**FINAL CLOSURE PLAN
LOPEZ CANYON SANITARY LANDFILL
LAKEVIEW TERRACE, CALIFORNIA**

**VOLUME IV OF IV REPLACEMENT
AMENDMENT TO FINAL CLOSURE PLAN**

Project Number CE4100-06

June 1996

**AMENDS DRAWING NO. 2 OF
VOLUME IV OF IV OF THE FCP**

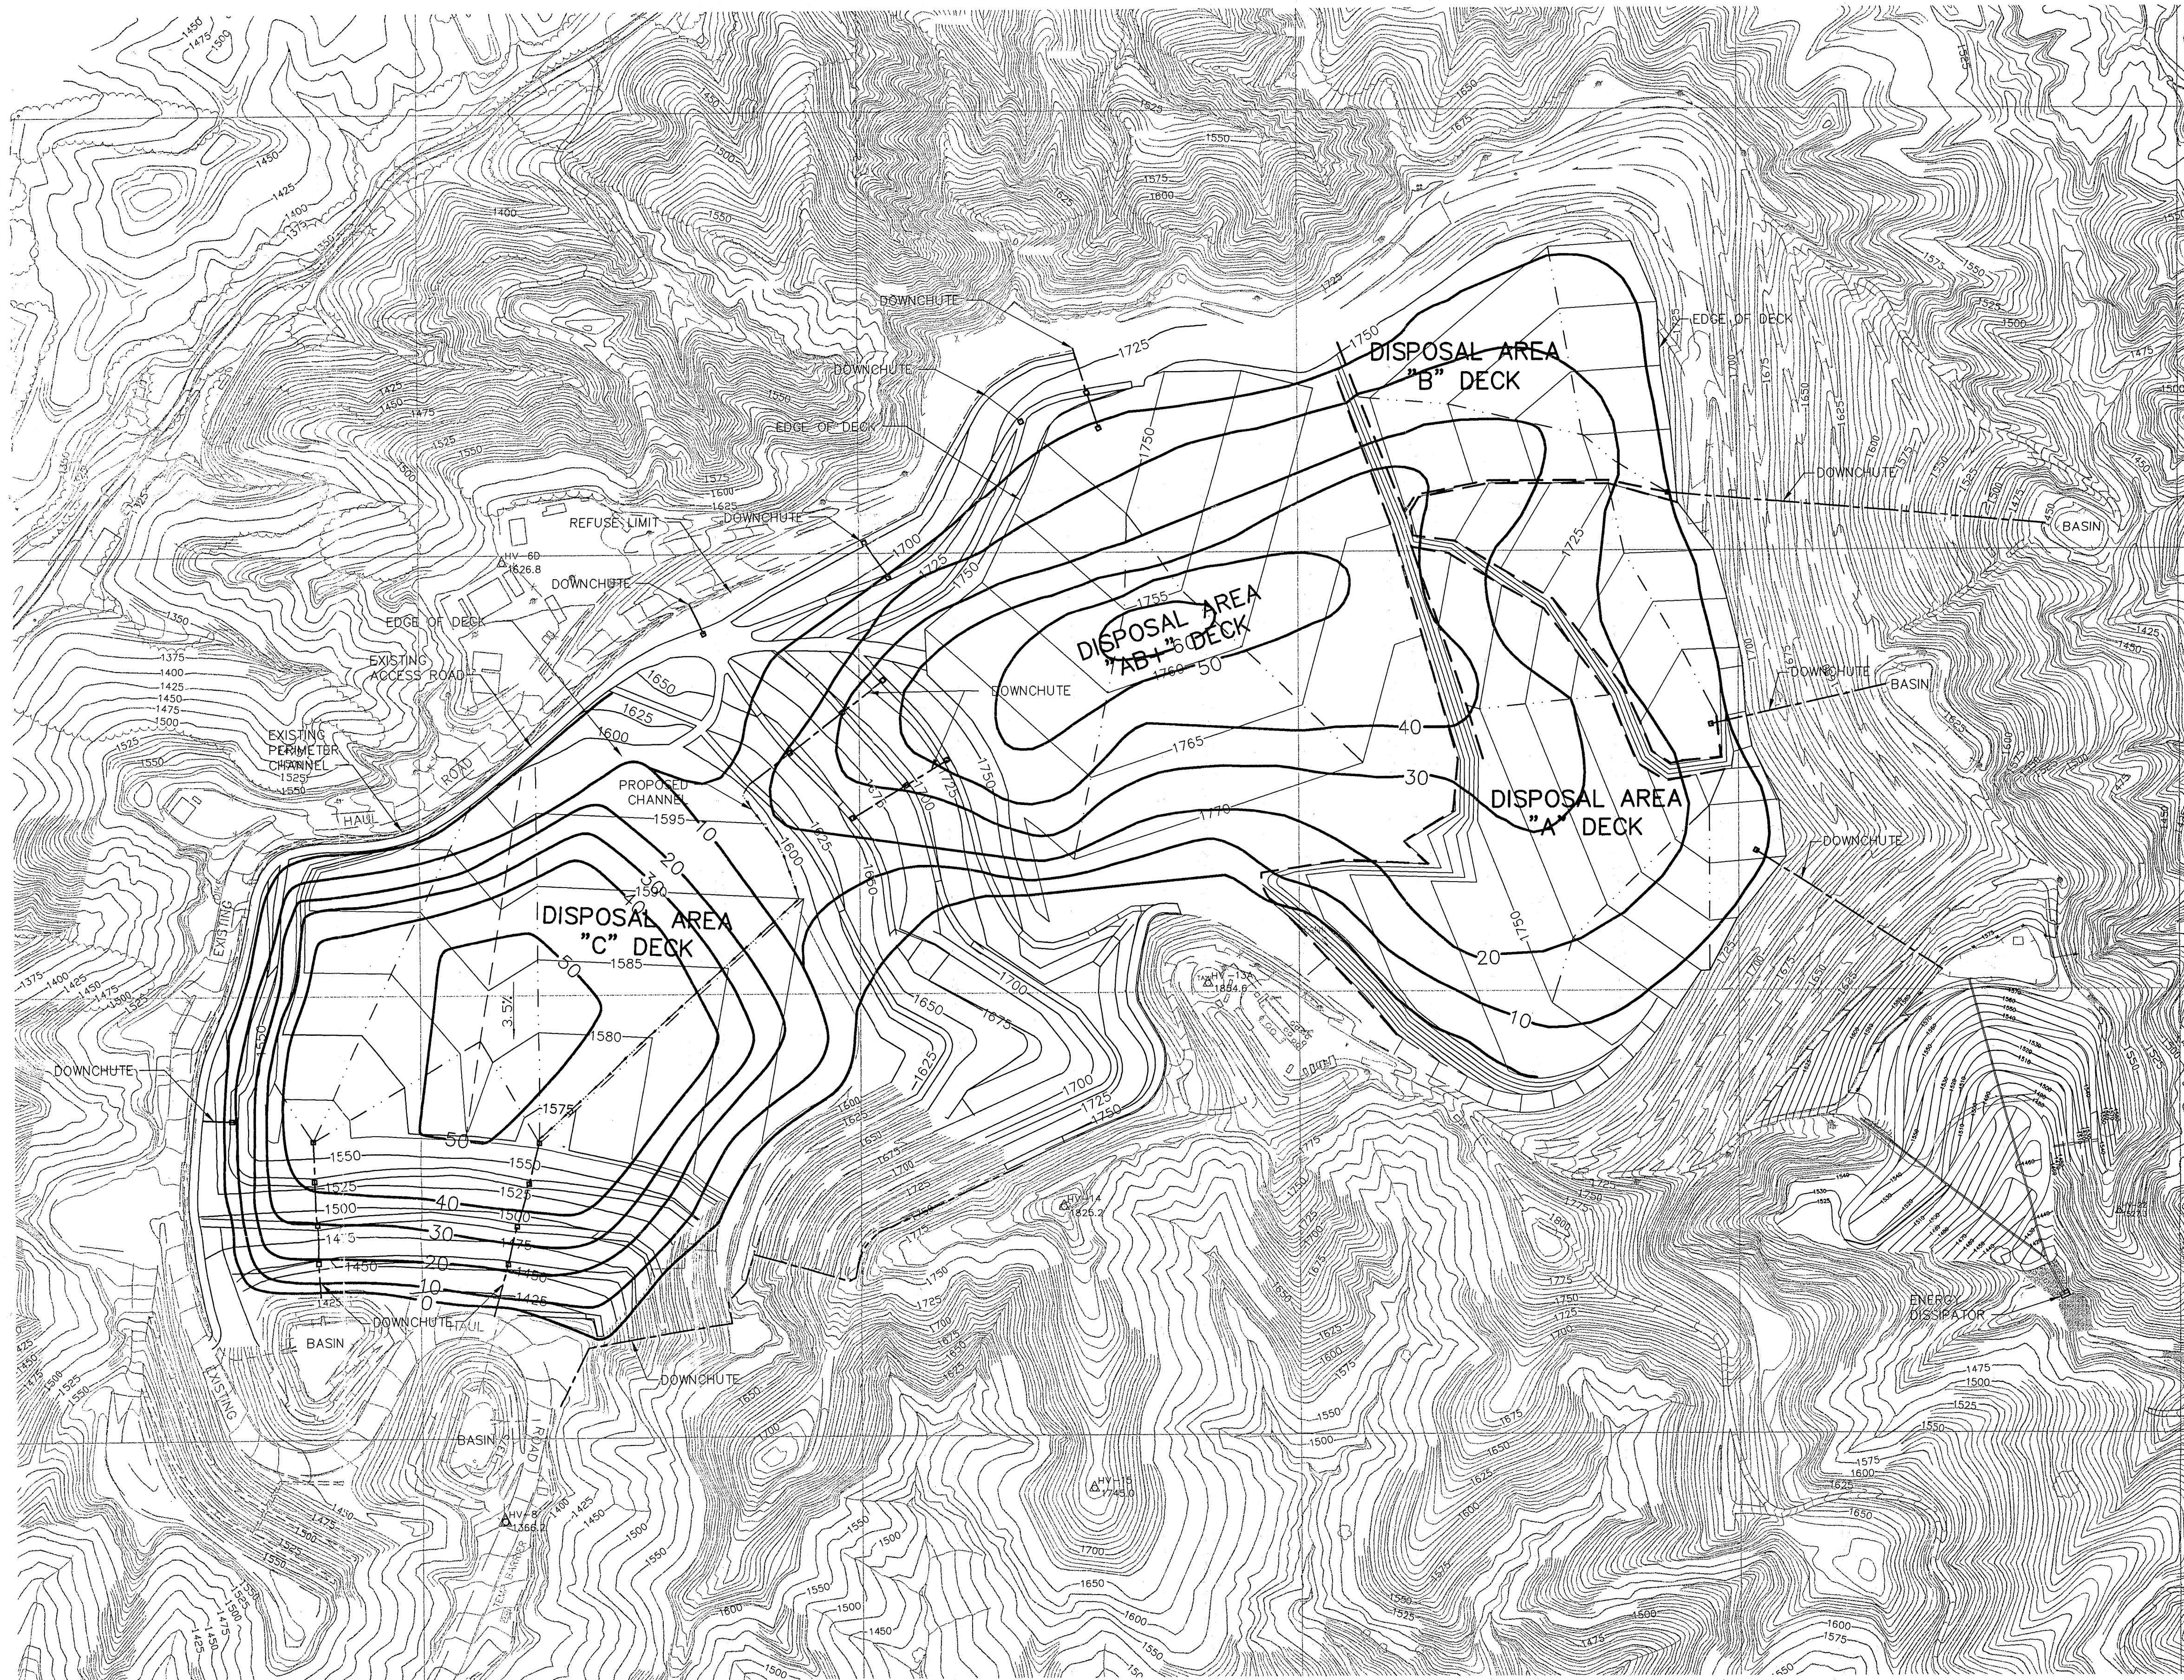
Final cover post-closure settlement estimates were presented in Section 4.8 of the FCP as 30 percent of the total waste thickness. Based on the revised final grading design for Disposal Areas AB+ and C (Figure 3-1, Drawing 1 of this addendum), the bottom liner grading plan for Disposal Area C, and historical topographic maps for Disposal Area AB+, a revised post-closure settlement contour map was developed for Disposal Areas AB+ and C. The revised post-closure settlement contour map is presented as Figure 4-1 and Drawing No. 2 of this amendment.

**AMENDS DRAWING NO. 3 OF
VOLUME IV OF IV OF THE FCP**

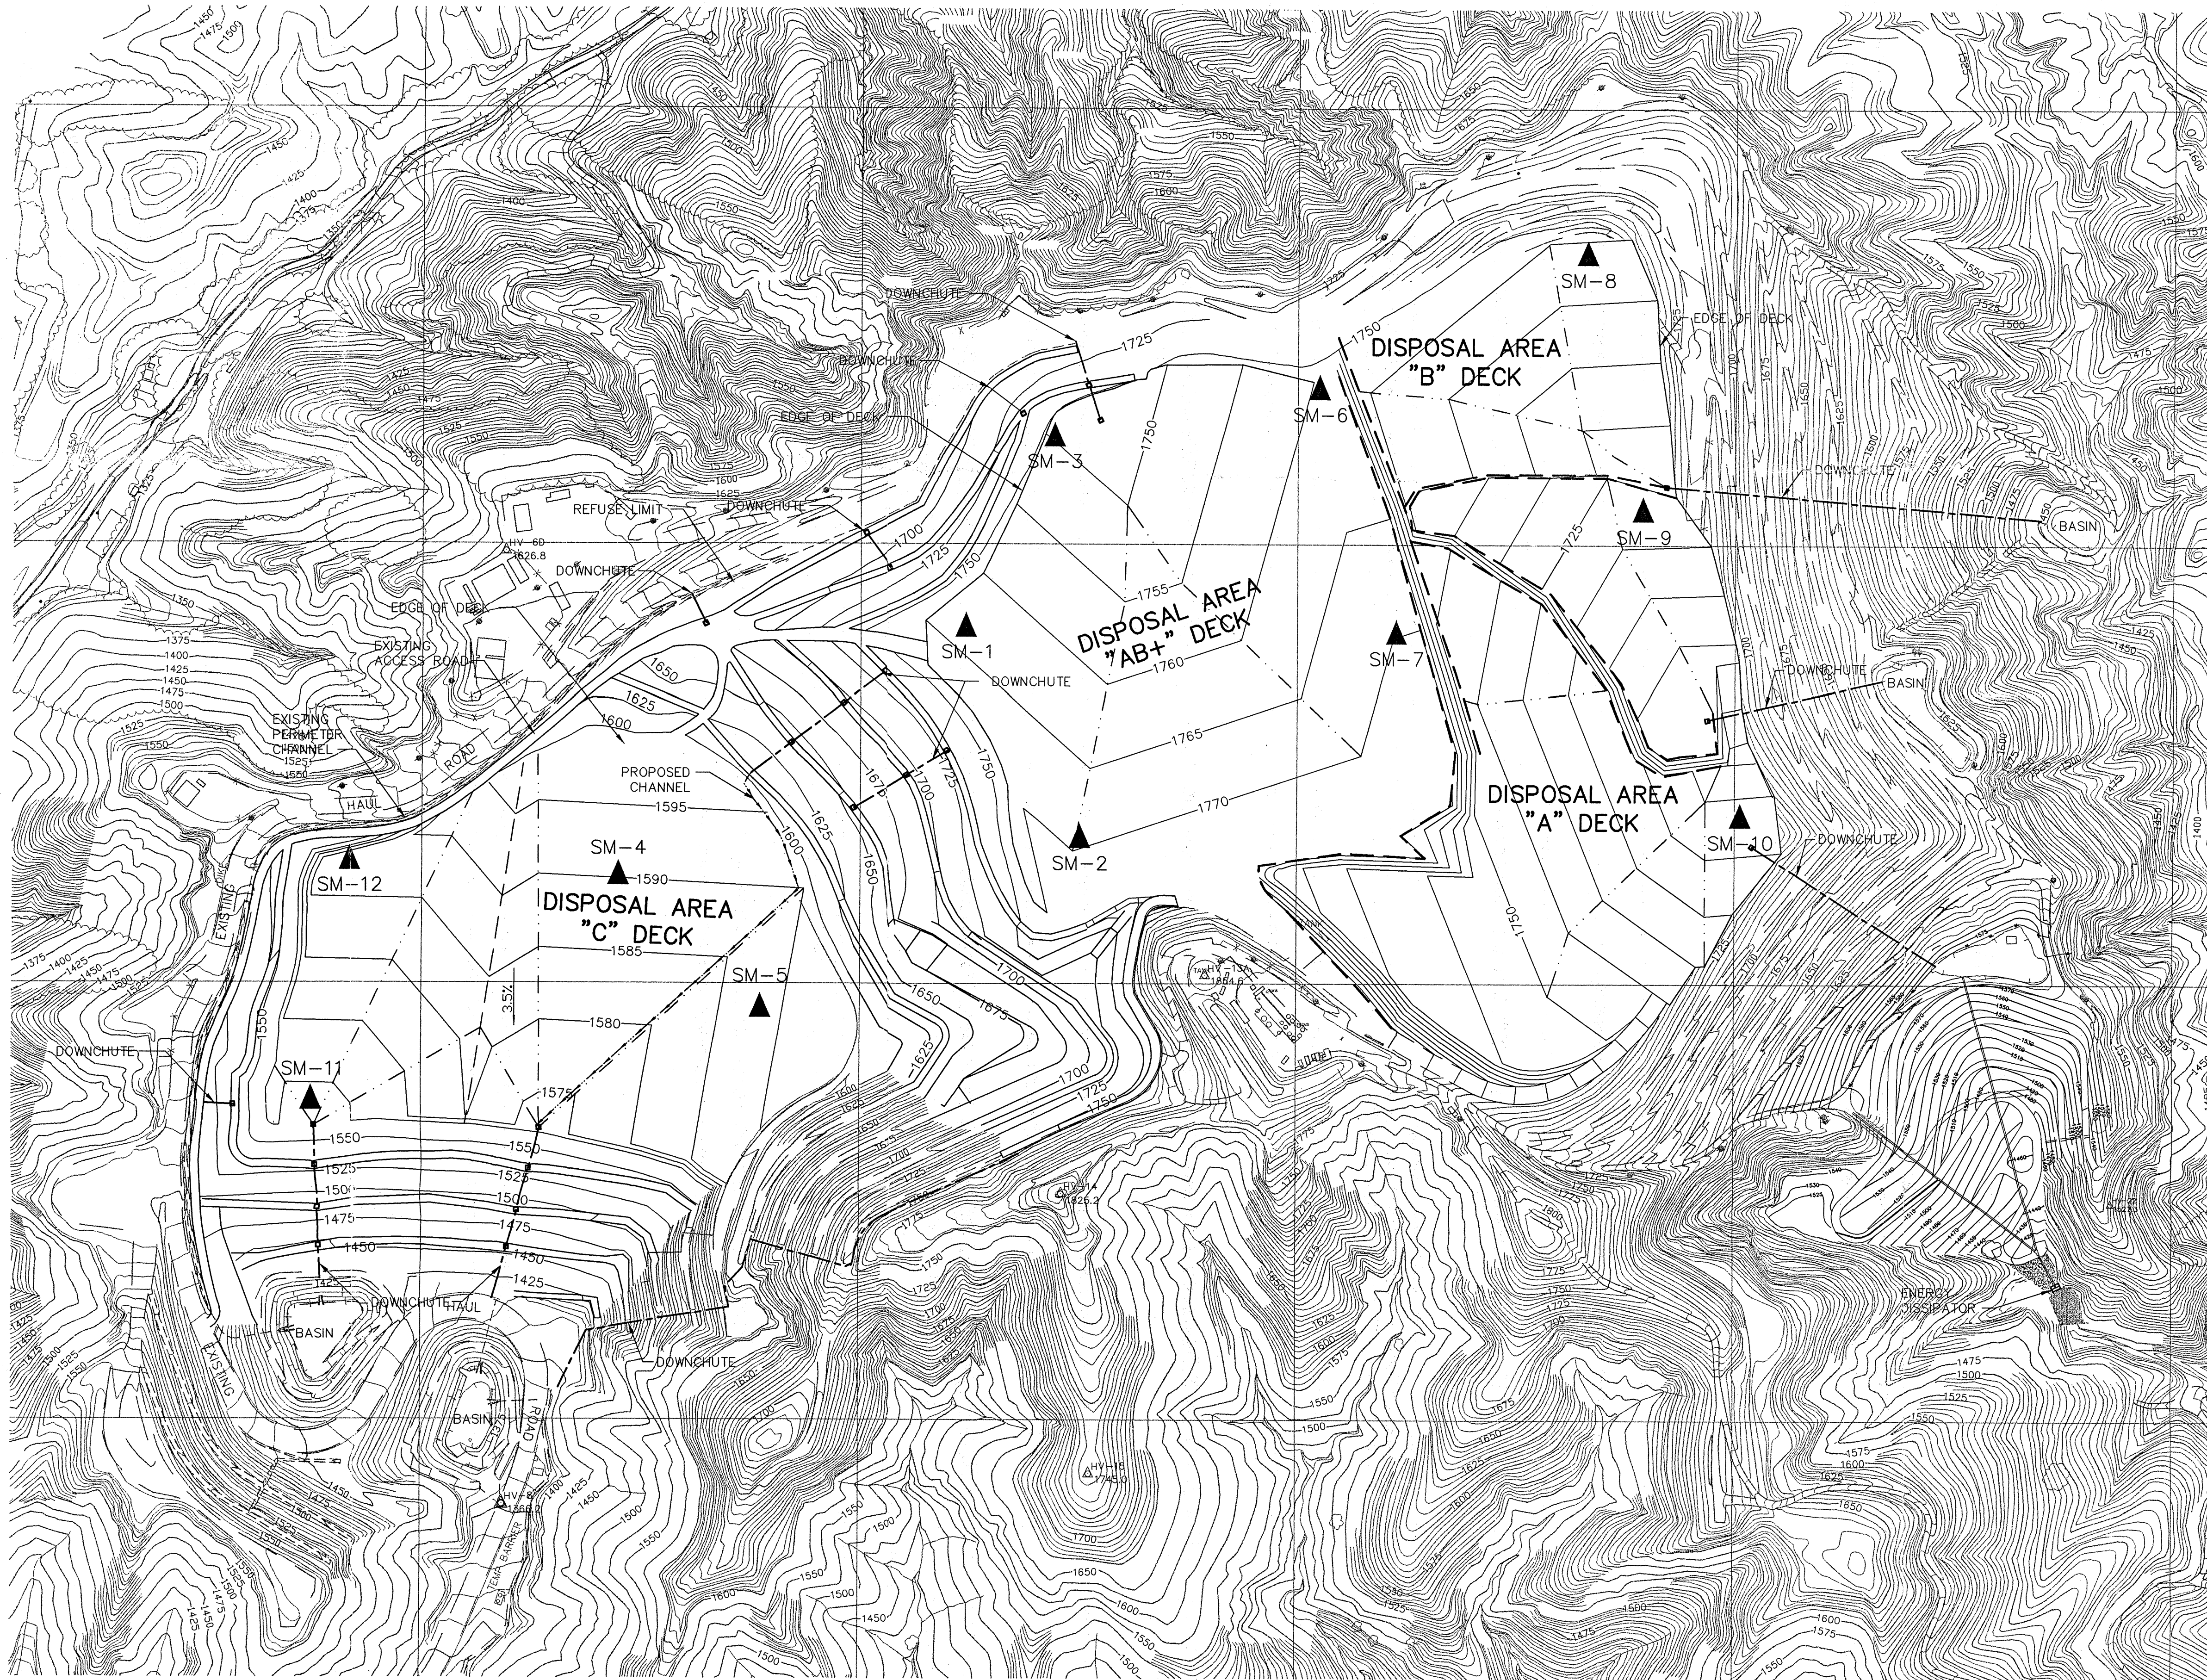
The FCP presented the location of ten settlement monuments. Due to the revisions to the final grading design, several of these settlement monuments were relocated and two additional settlement monuments are proposed. The revised locations of the settlement monuments are presented in Figure 4-2 and Drawing No. 3 of this amendment.
